**FRANKLIN COUNTY  
I-64  
RELOCATION & WIDENING  
BETWEEN  
US 127 AND US 60**

**VALUE ENGINEERING STUDY -  
FINAL REPORT**

**FRANKLIN COUNTY I-64  
RELOCATION AND WIDENING  
BETWEEN US 127 AND US 60  
KTC Item #5-56.00  
KTC State Project #FD520370064053-058017D  
FHWA #NH00644070**

**VALUE ENGINEERING STUDY  
for  
Kentucky Transportation Cabinet**

## SKETCH OF ORIGINAL DESIGN

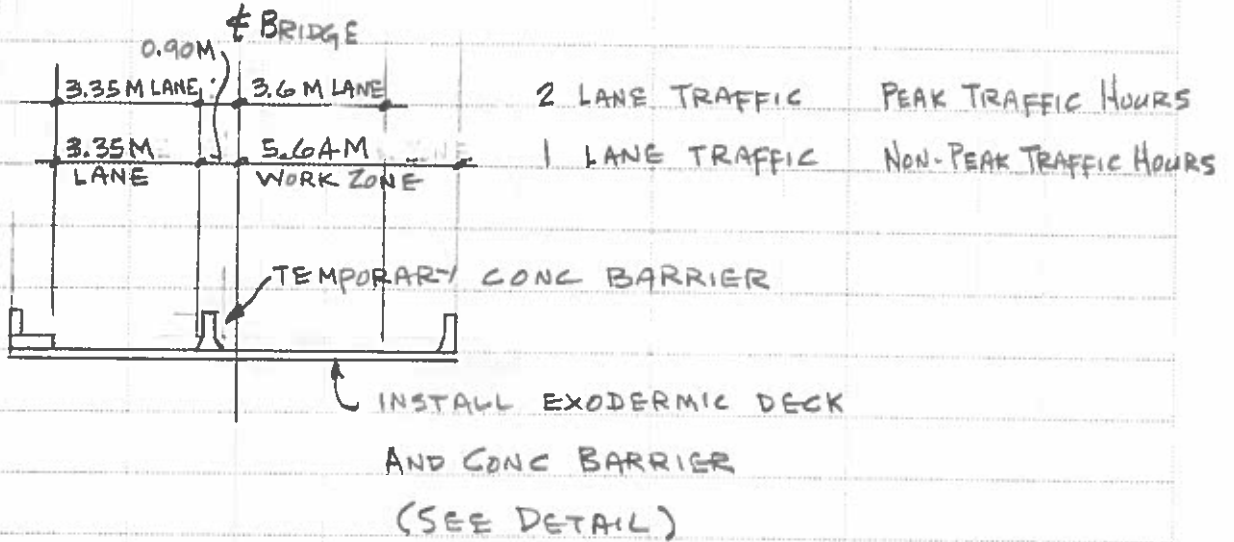
Widen I-64 to three lanes eastbound and westbound from US 127 interchange to US 60 interchange. A fourth truck climbing lane to be added eastbound between the east end of the Kentucky River bridge and the west end of the US 60 bridge. Three lanes to be carried westbound through the US 127 interchange and eastbound through the US 60 interchange. Four bridges to be replaced and one bridge to be widened. Stage construction to be used to maintain two lane traffic in each direction. With traffic using the existing roadway initial widening to be generally to the inside of the existing alignment placing sufficient roadway and shoulder to allow two lane traffic during the stage when the existing roadway is rebuilt to the new template.

Place a high quality asphalt overlay over the roadway in each direction and replace the decks of the Kentucky River bridges. The decks of the Cedar Run Creek and Johnson Road bridges were overlaid during the summer of 1996 and rehab is not expected. Because there are no alignment changes, no rehab work is anticipated for the Henley Lane bridge over I-64 and the I-64 bridge over US 60. One lane traffic to be maintained at all times with no lane closures permitted during peak traffic hours. The lane closure to be generally during the night with work scheduled so that two lane traffic can be resumed for morning rush hour traffic. Day work shall likewise be scheduled to resume tow lane traffic for the afternoon rush hour. To minimize motorist inconvenience, the Kentucky River bridge deck replacement to be completed before beginning the roadway overlay. An Exodermic Deck system using precast concrete slabs to be specified to complete the deck replacement in the least amount of time. The current curb and parapet bridge railing to be replaced with barrier curbs.

## SKETCH OF ORIGINAL DESIGN

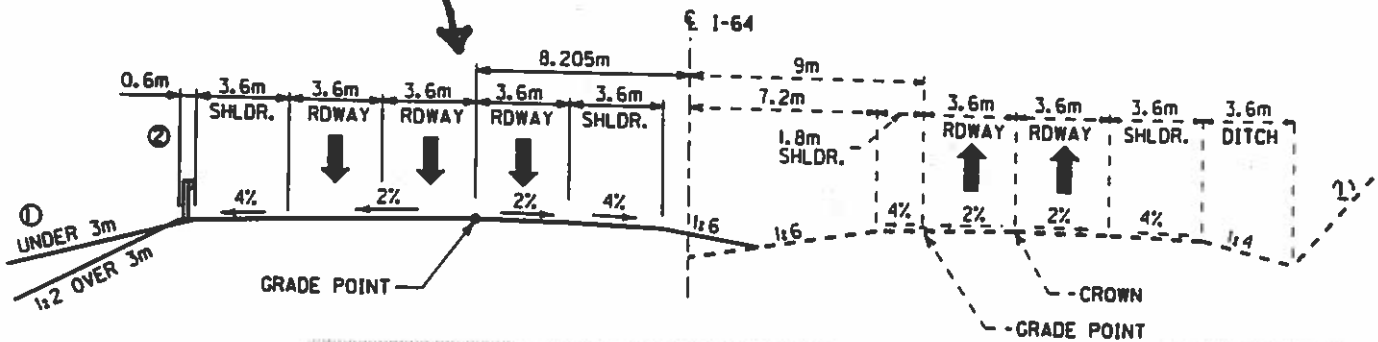
The original design moves the roadway alignment into the median. Three new lanes with shoulders and new ditches will be built in each direction. Most of the space occupied by the existing roadway will be used to build a 30 foot clear zone, improve the shoulder width and provide space for an 18 foot fall bench for the rock cut sections. An additional truck lane is provided for trucks u the hill in the eastbound direction beyond the Kentucky River bridge. All shoulders, guardrails, guardrail end treatments, and clear zone requirements are built to current design standards.

SKETCH OF RECOMMENDED DESIGN

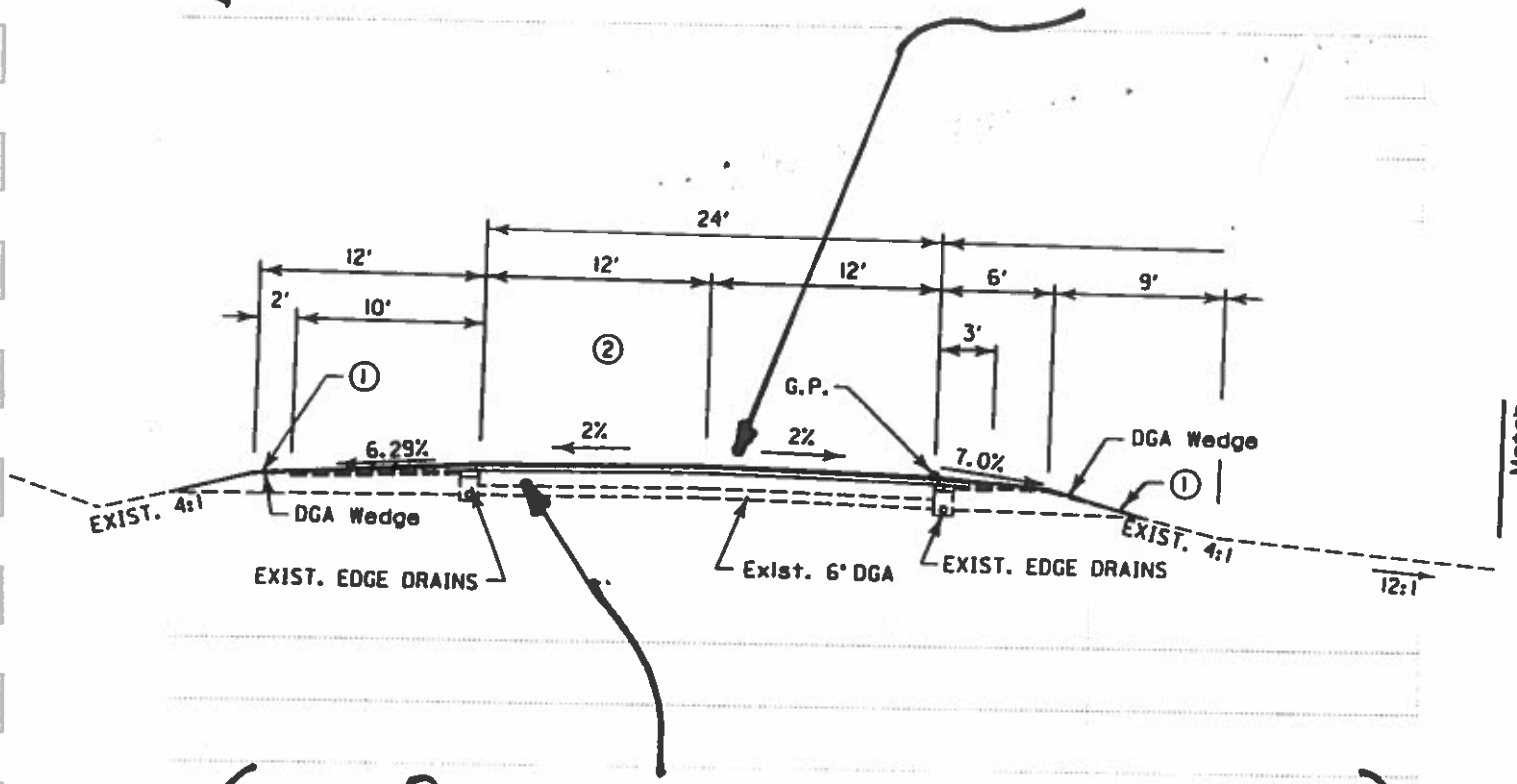
The existing pavement life can be extended by twenty or more ears through pavement rehabilitation. The recommended method is breaking and seating of the existing concrete pavement and adding a thick asphalt base and surface on top. This asphalt surface would be approximately 8 inches total thickness. The shoulders are currently constructed with asphalt. The same thick overlay would be added to the shoulders. Shoulder asphalt could be added in variable lifts during construction and would enable the contractor to maintain an additional traffic lane on the shoulder to facilitate traffic flow. The inside and outside shoulders will be widened to current standards and slopes flattened to required limits. Obstacles in the clear zone will be removed or protected by guardrails or barriers. The existing guardrail throughout the project will be replaced and receive current safety end treatments. Additional guardrail will be installed when required unneeded guardrail will not be reinstalled. Acceleration/deceleration lengths will be lengthened when appropriate. Ramps will be resurfaced if needed.

BREAK AND SEAT THE EXISTING  
PAVEMENT. ADD THICK OVERLAY  
TO LANES AND SHOULDERS.  
ADD POLYMERS TO EXTEND LIFE

## SKETCH OF RECOMMENDED DESIGN

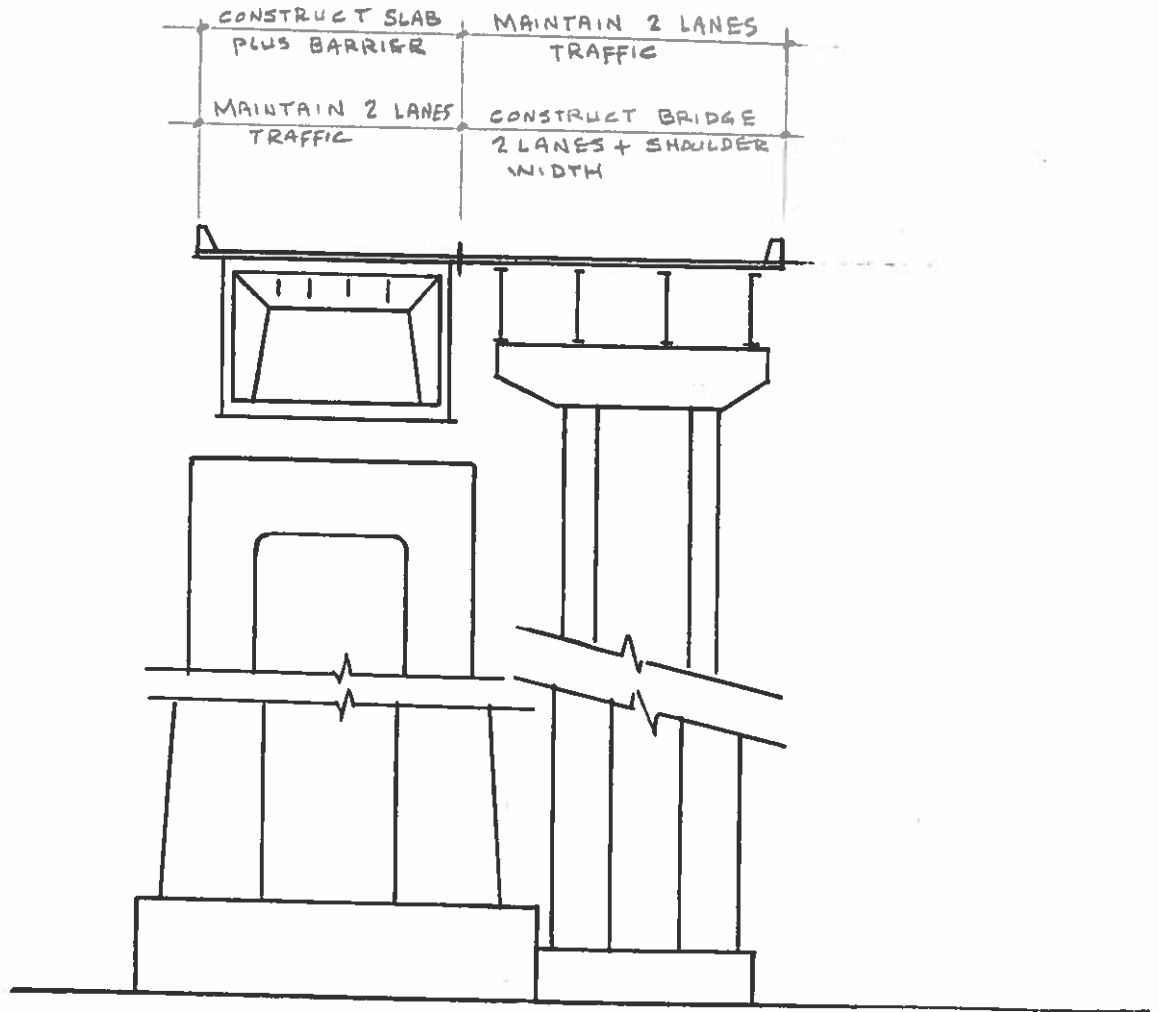
The recommended method is to build a new structure immediately beside the old one. The new bridge will be at least three lanes wide. When this new structure can be opened to traffic, the deck of the old bridge will be replaced. A new deck is added and the resulting structure, existing bridge plus adjacent new bridge, is 3 lanes and 2 shoulders wide. The existing beams are incorporated into the "new" bridge.

## SKETCH OF RECOMMENDED DESIGN

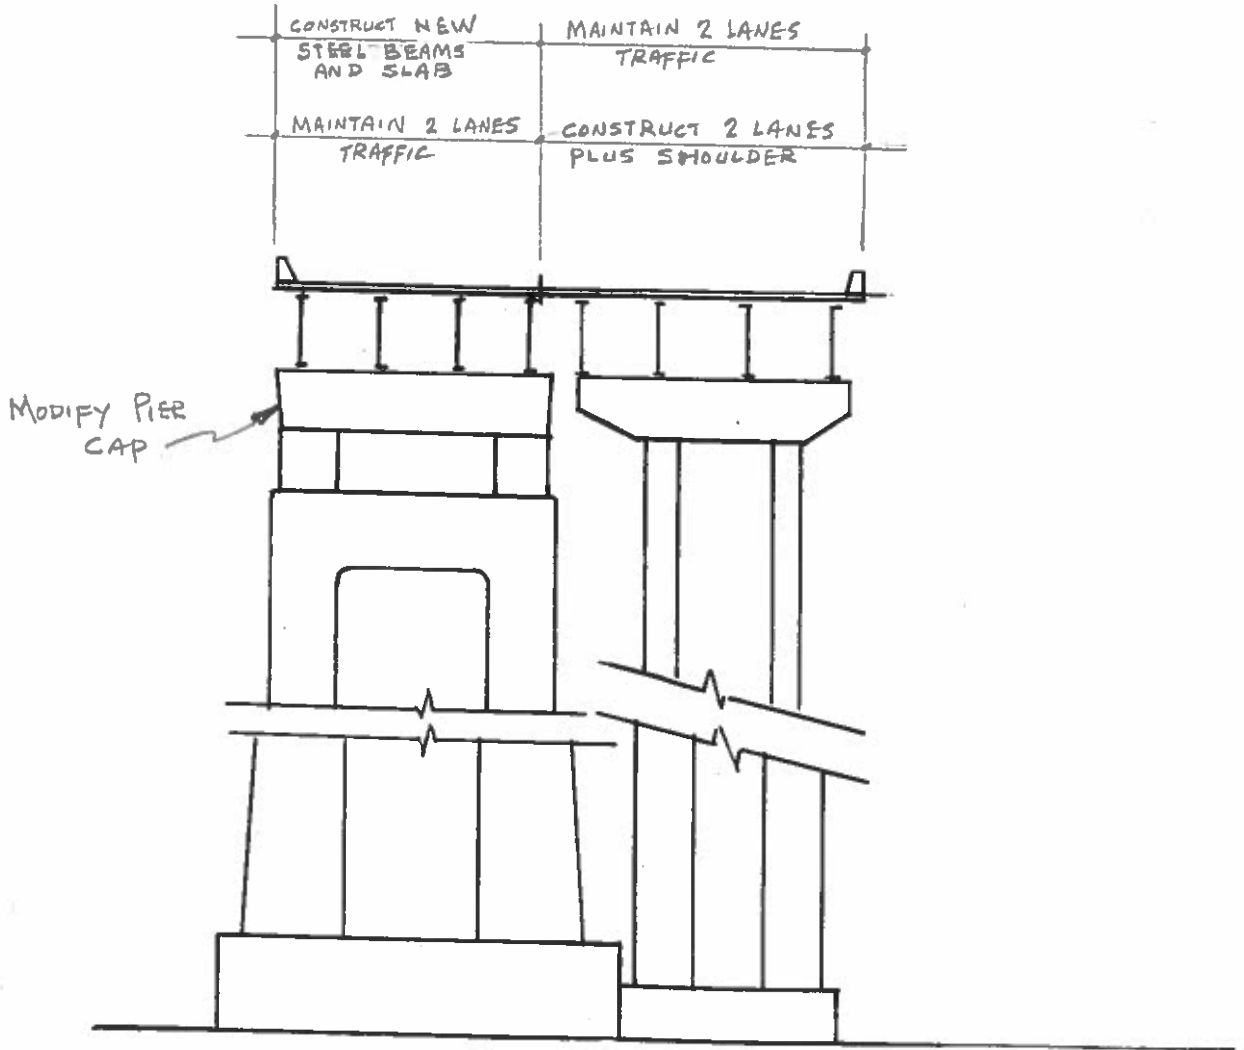
The recommended method is to build a new structure immediately beside the old one. This new bridge will be two lanes plus a shoulder. When this new structure can be opened to traffic the deck and beams from the old bridge will be demolished. The old pier will be modified to enable new beams of like size to be incorporated into the "new" structure.

SKETCH OF ORIGINAL DESIGN

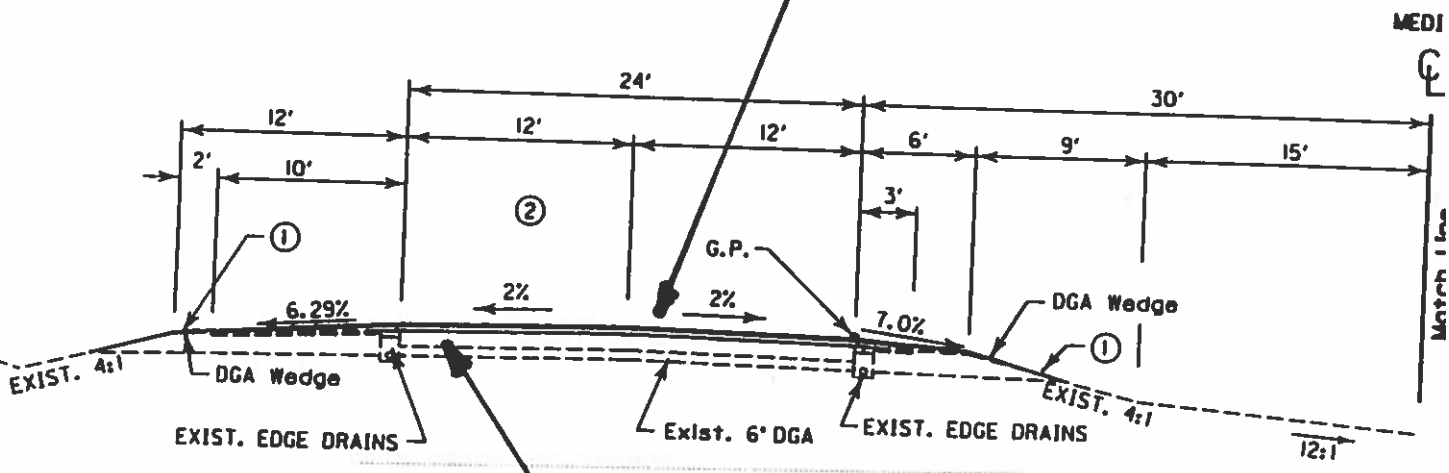
ORIGINAL DESIGN  
ADD 4 INCHES ASPHALT WITH  
POLYMER MODIFIERS THROUGHOUT  
THE PROJECT

SKETCH OF RECOMMENDED DESIGN

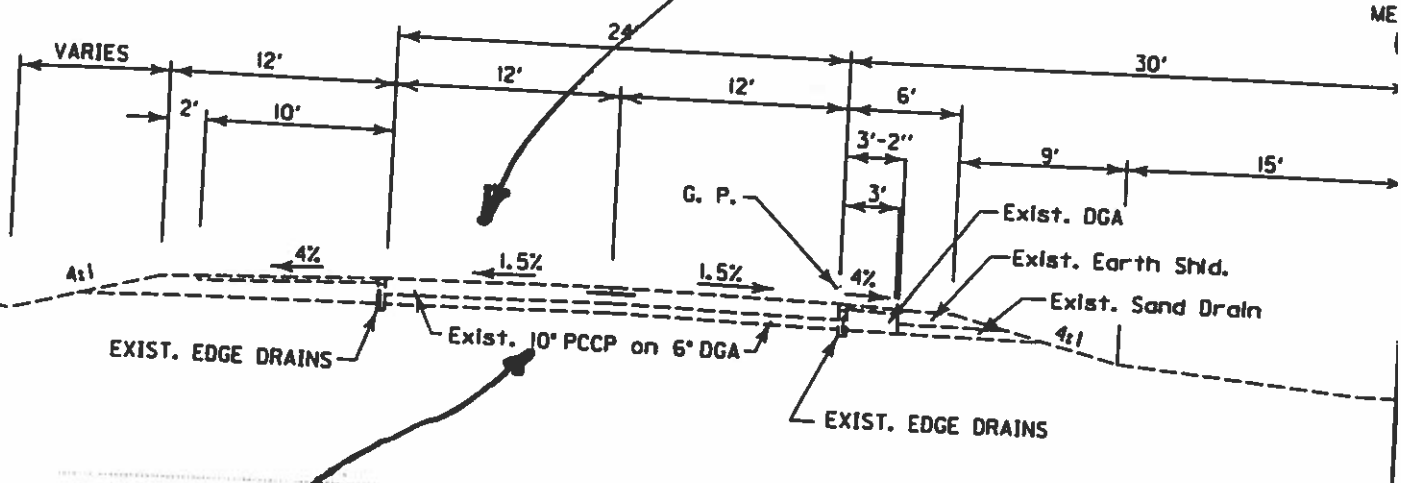
It is recommended that this amount of money not be spent on items that will be replaced or reconstructed in less than 3 years. Rather than providing a total overlay of the entire route consider patching only those areas that are unacceptable now and include items in the construction contract to repair other sections when and if they deteriorate. As a minimum, the proposed overlay should be delayed until the reconstruction/widening plans are completed and a method to maintain and control traffic are discussed.

ADD 4 INCHES IN THE DRIVING  
LANES AND A VARIABLE  
TAPER ON SHOULDERS

ALTERNATE No. 2  
WITH RECOMMENDED CHANGE

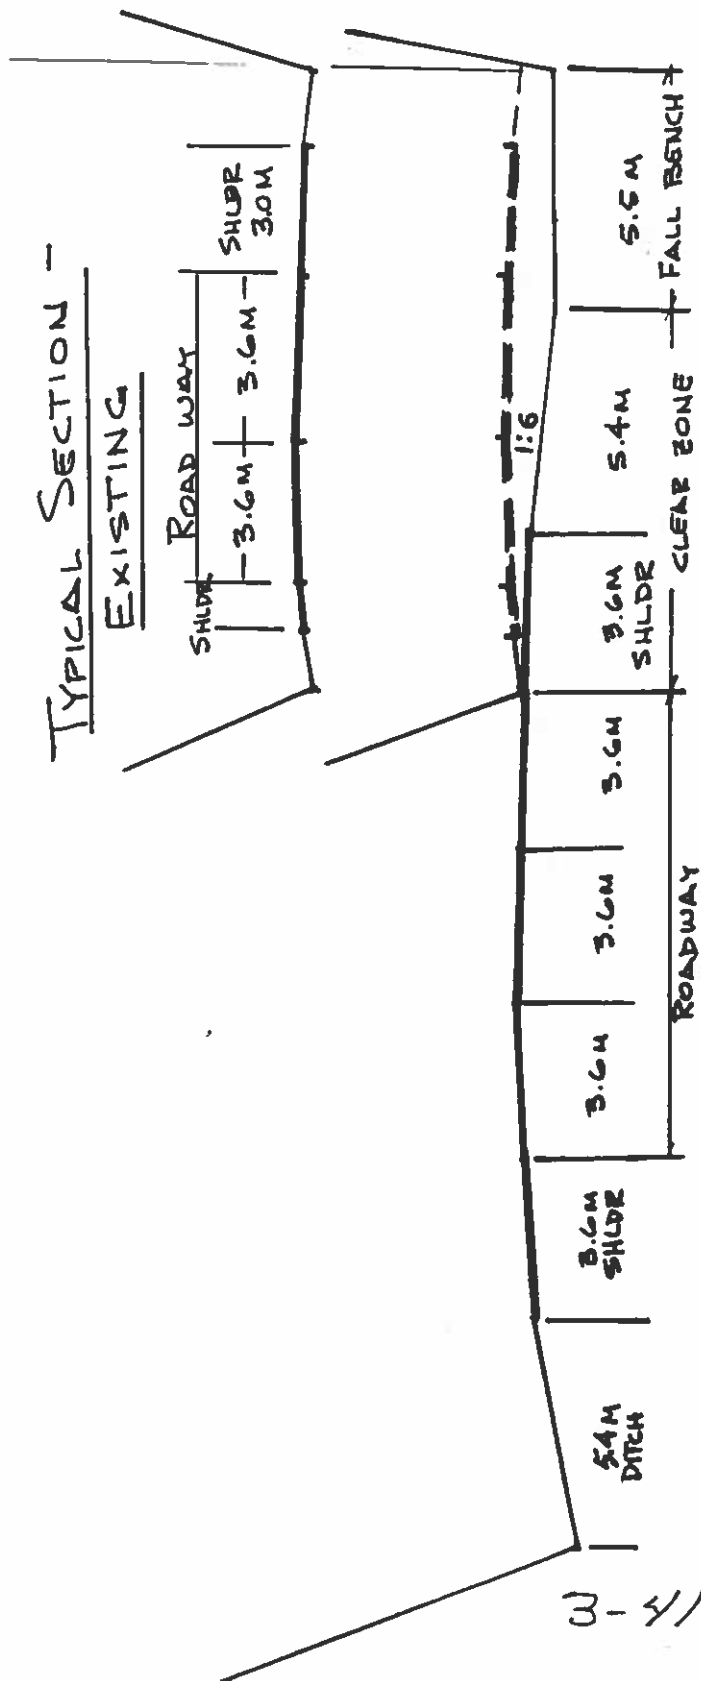
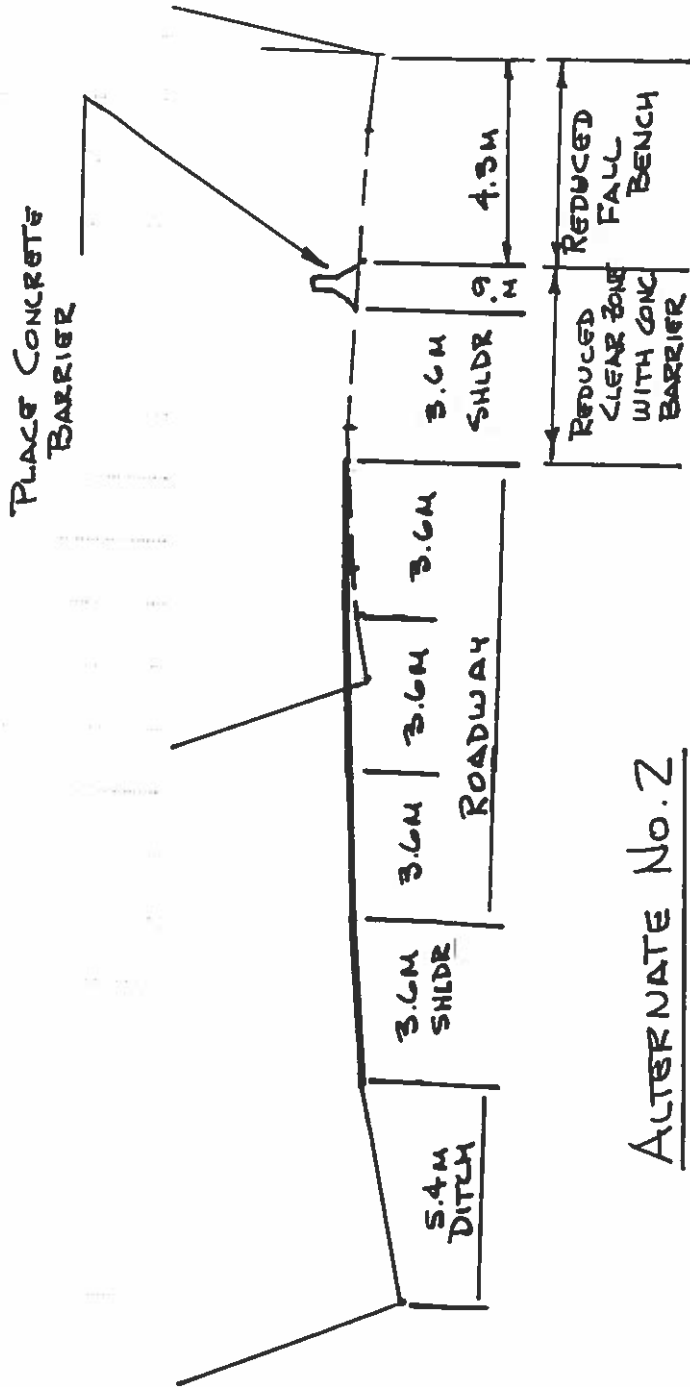
The recommended change is to place a concrete barrier on the outside edge of the new shoulder thus allowing a defined fall bench with a minimum width of about 4.3 m.

## SKETCH OF RECOMMENDED DESIGN

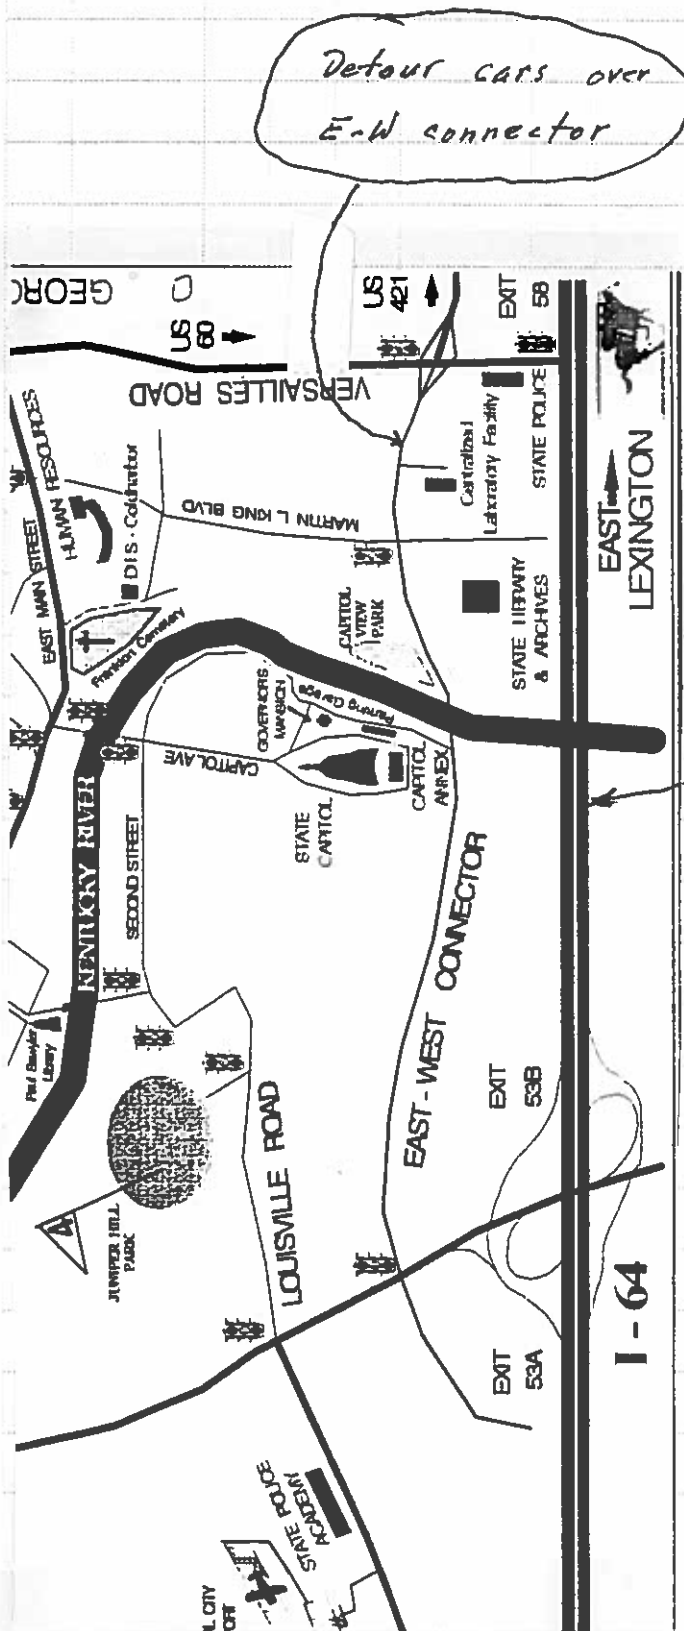
Travel time between intersections via Rte. 676 is approximately 15 minutes. Delays on I-64 on the order of 20-30 minutes can be expected, especially during bridge deck rehabilitation if pilot cars are used to control speeds. Separation of cars and trucks should reduce delay for cars by avoiding the construction entirely, and reduce delay for trucks by reducing the total number of vehicles on the single lane portion of I-64. Rte. 676 appears to be a good detour.

1. Detour to be maintained for 1 year
2. Purchase message sign and flashing arrow. Provide man to maintain.
3. Mobilize and demobilize equipment
